SERVICE BULLETIN

N° 189-275

ATA 11 – DUAL HOIST KIT DECALS REPLACEMENT

Figure 1

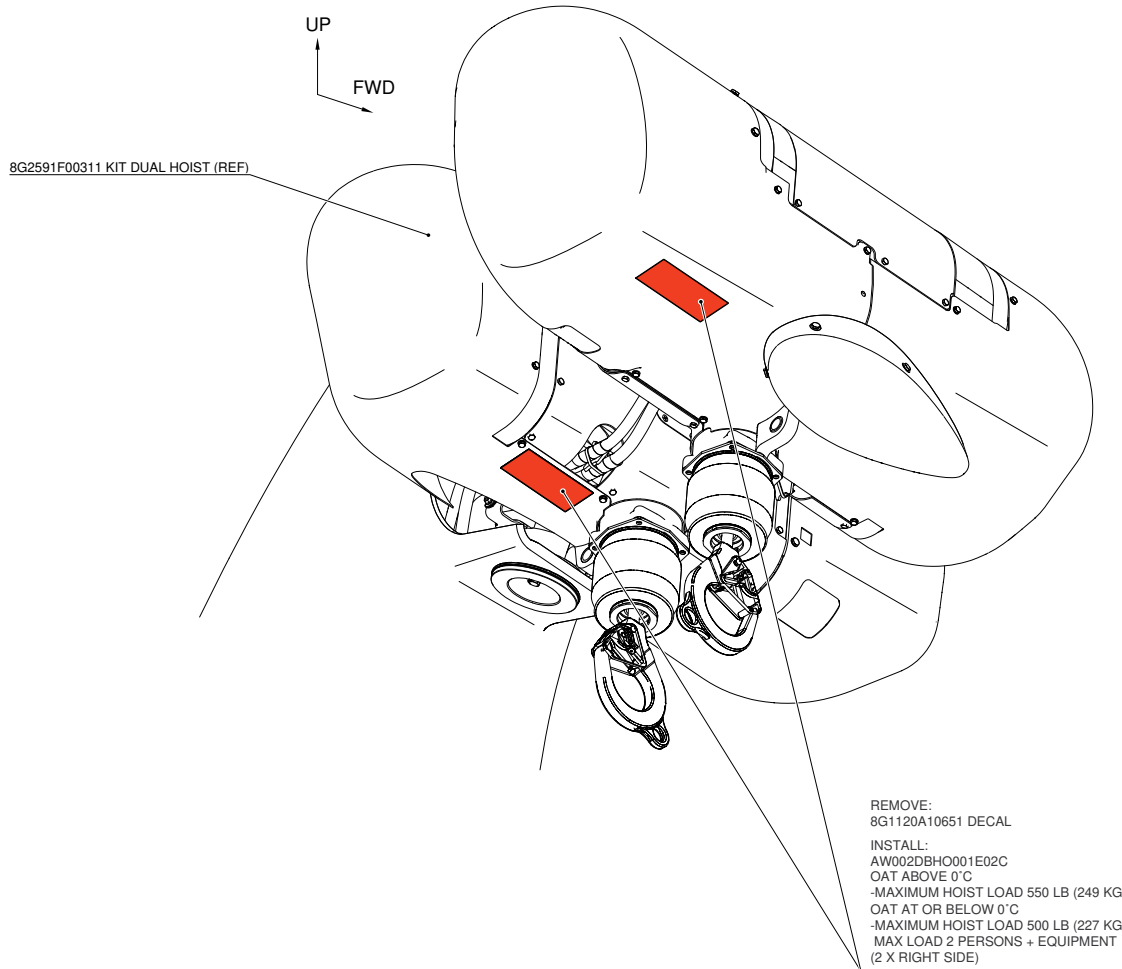
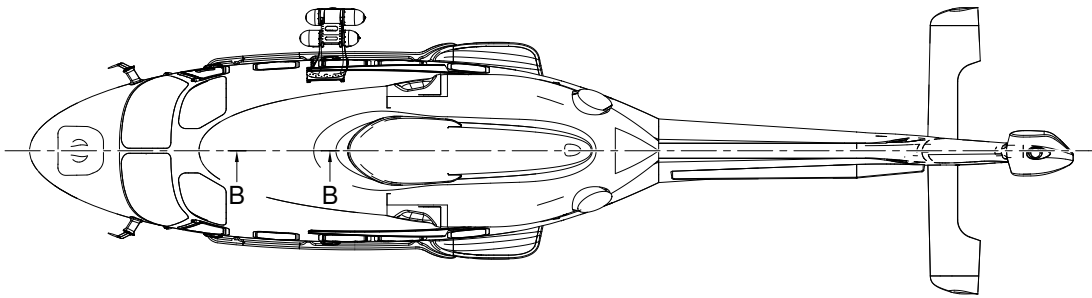
Three rescue hoist decals, in Russian and English languages, report an incorrect indication of the maximum hoist load allowed at 0°C OAT. The decals P/N 8G1120A10651 and P/N 8G1130A17851, currently installed, report a maximum hoist load of 550lb at 0°C OAT while the correct value is 500lb.

2. In accordance with AMP DM 89-A-06-41-00-00A-010A-A and with reference to Figures 1 and 2, gain access to the area affected by the installation.
3. In accordance with AMP DM 89-A-11-00-01-00A-520B-A and with reference to Figure 1, remove n°2 decals P/N 8G1120A10651 from the external fairings of kit dual hoist.

5. In accordance with AMP DM 89-A-11-00-01-00A-720A-A and with reference to Figure 1, install n°2 decals P/N AW002DBHO001E02C on the external fairings of the kit dual hoist.

The incorrect decals will be replaced with the equivalent one only in English language reporting the correct hoist maximum load for 0°C OAT condition.

Figure 2

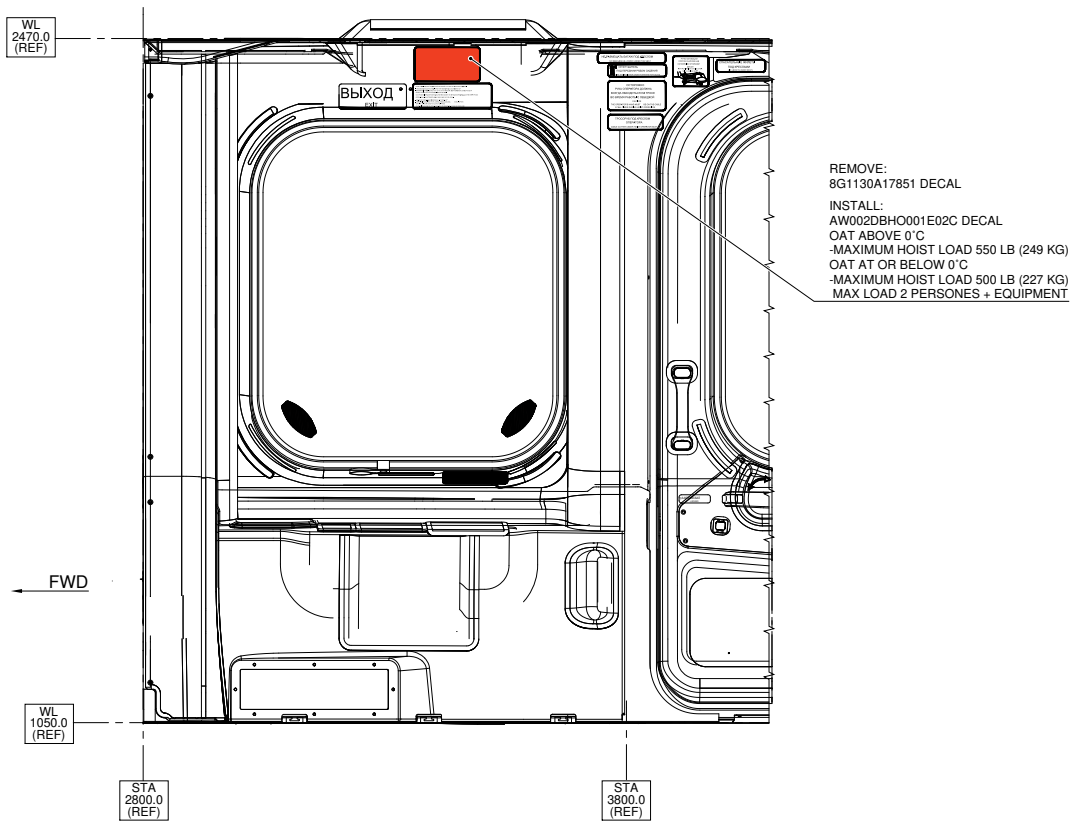
4. In accordance with AMP DM 89-A-11-00-01-00A-520B-A and with reference to Figure 2, remove the decal P/N 8G1130A17851 from the indicated position inside the helicopter cabin.

6. In accordance with AMP DM 89-A-11-00-01-00A-720A-A and with reference to Figure 2, install the decal P/N AW002DBHO001E02C on the indicated position inside the helicopter cabin.
